Ford Site, Cork City, Co. Cork

Stage 1 Road Safety Audit

240002-X-00-X-XXX-RP-DBFL-CE-0004

November 2024

Location (G1) – EV Car Parking Spaces

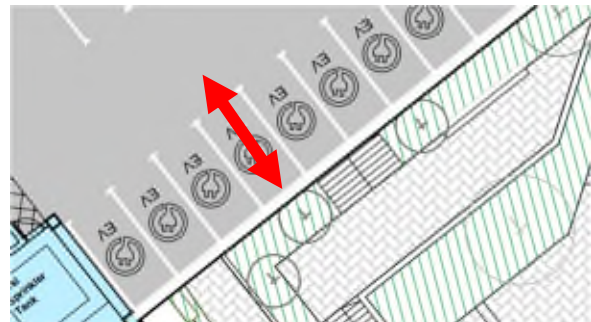
The width of the EV car parking spaces appear to be a similar width to the standard bays. It is unclear if any widening of spaces is proposed to accommodate pedestrian manoeuvrability within the space to connect EV chargers. Failure to provide a sufficient buffer zone between these spaces could result in the electric cables presenting trip hazards to vehicle occupants as they travel between their vehicle and the charge point.

In addition, at EV charger spaces where no buffer to the aisle is provided, it is unclear if the positioning of an EV charging unit will result in parked vehicles protruding into the aisle. Should vehicles protrude into the aisle, this could result in material damage to vehicles should a collision occur between vehicles exiting the spaces on the opposite side of the aisle or with vehicles travelling past.

A sufficient buffer zone should be provided between EV charger bays. EV charger units should be positioned so that vehicles are able to be parked within the bay.

Location (G2) – Existing Ponding

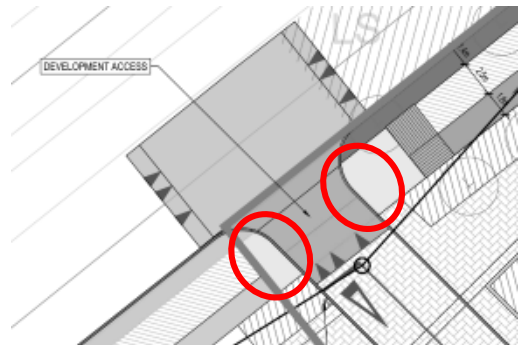
At the time of the site visit, which took place after a consistent period of rainfall, there was evidence of ponding to the west of the proposed site access location. The auditors are concerned that further development in this vicinity could exacerbate this existing problem. Excessive ponding

could cause aquaplaning as cars travel through affected areas or slippery conditions during freezing temperatures which could result in vehicle loss of control type incidents.

It is recommended that the design team take cognisance of the existing drainage issues in their design.

Location (S2) –Site access junction control

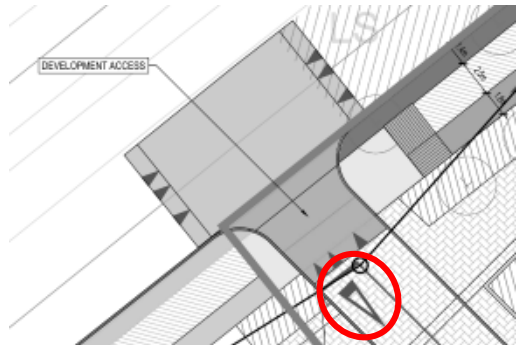
A Yield arrangement is proposed at the site access junction. This junction control coupled with the slightly skewed approach to the junction could result in drivers failing to stop before entering the main road potentially leading to vehicle / vehicle collisions should a visibility splay not be achievable for a Yield arrangement.

It is recommended that the more onerous visibility splay required for a Yield arrangement are achievable. If this is not achievable, a STOP control arrangement should be provided.

Location (S3) – Car Park Arrangement

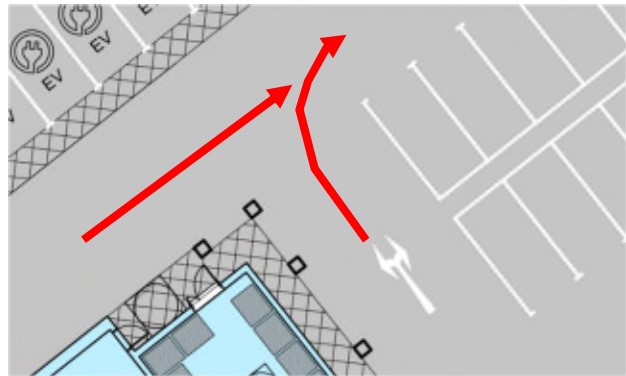
A one-way arrangement is proposed within the undercroft car park. At the location where the southern car park section joins the northern section, no junction control is proposed. This could result in confusion as to who has priority potentially leading to vehicle collisions.

At detailed design stage, the priority arrangement within the car park should be made obvious.
